PROJECT NAME: Humboldt Project Attachment A.1

PROPOSED DEVELOPMENT ADDRESS:
Humboldt & Van Vechten Sts.

PROJECT DESCRIPTION:
• 3-Lot Subdivision
• 1-Lot Subject to Review

Re: Submission Information
Requested by Planner on Feb. 21, 2012 letter – Humboldt Project

C100

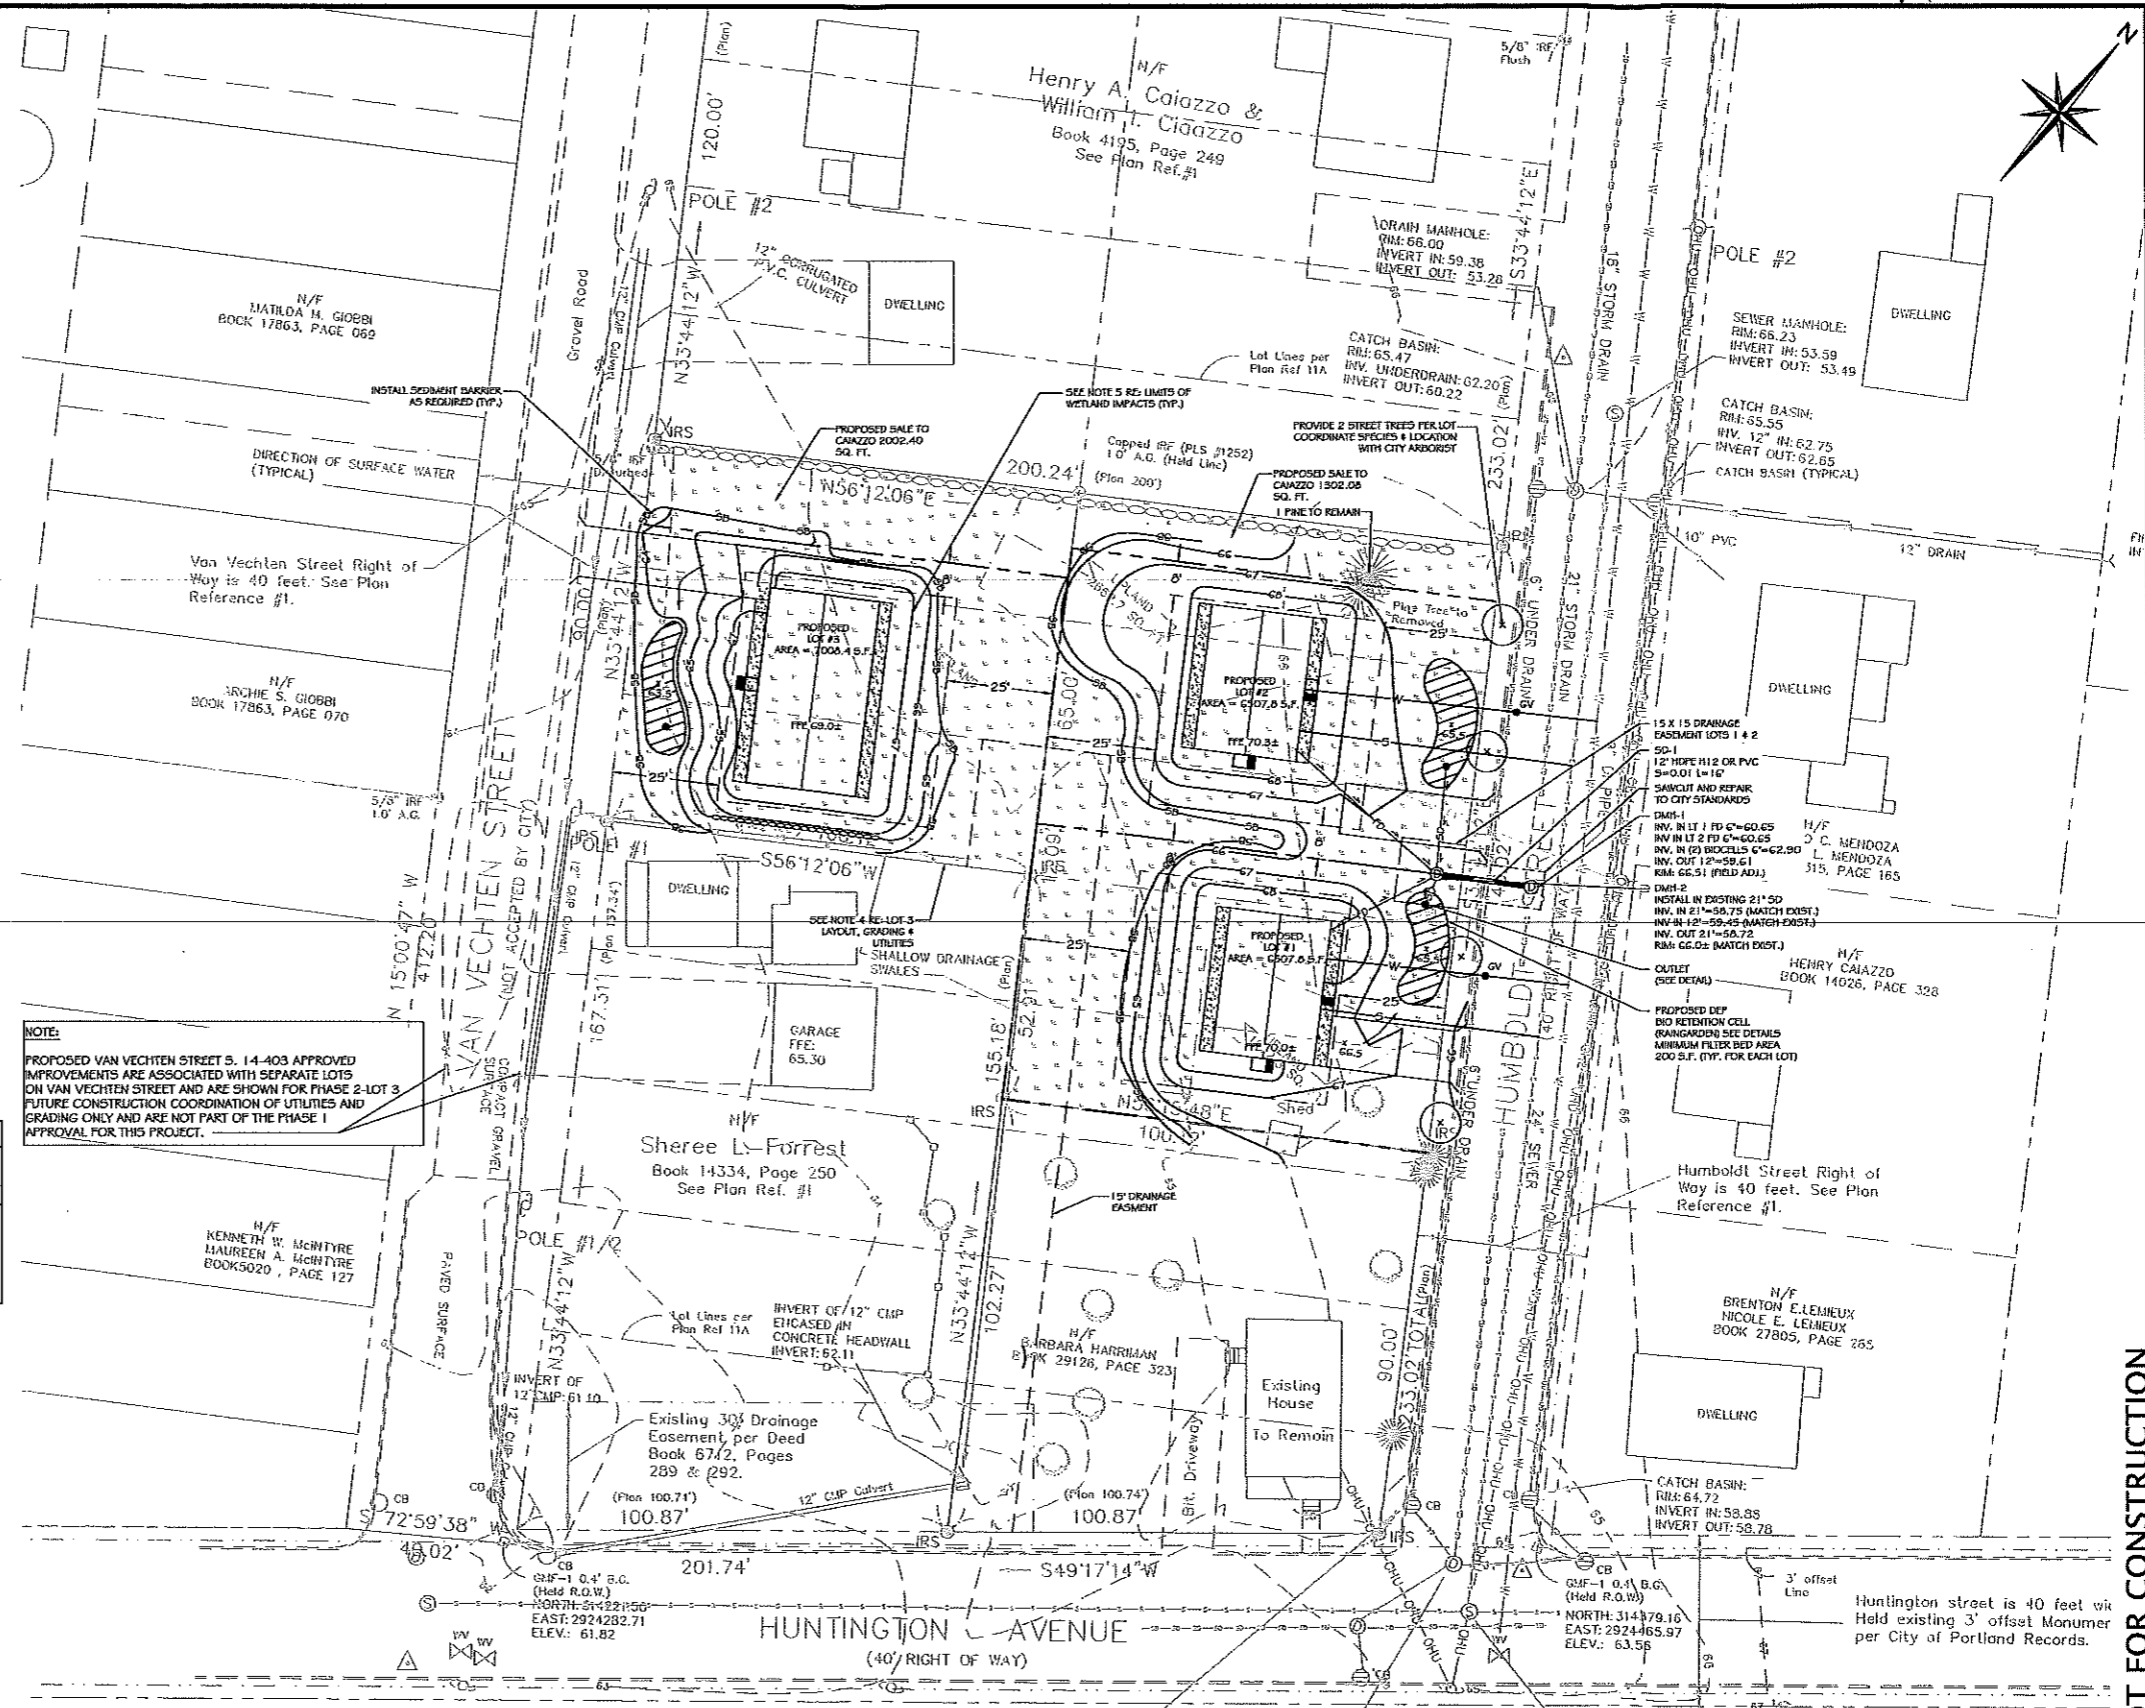
6. On Sheet C100, it appears that the leaders and notes for DMH 1 & DMH 2 point to the incorrect structures. Please clarify.
7. On Sheet C100, Pipe SD 1 is called out as HDPE or PVC. The City does not allow HDPE pipe within the Right-of-Way. Acceptable pipe options are noted in Section 2.5.2 of the City's Technical Manual.
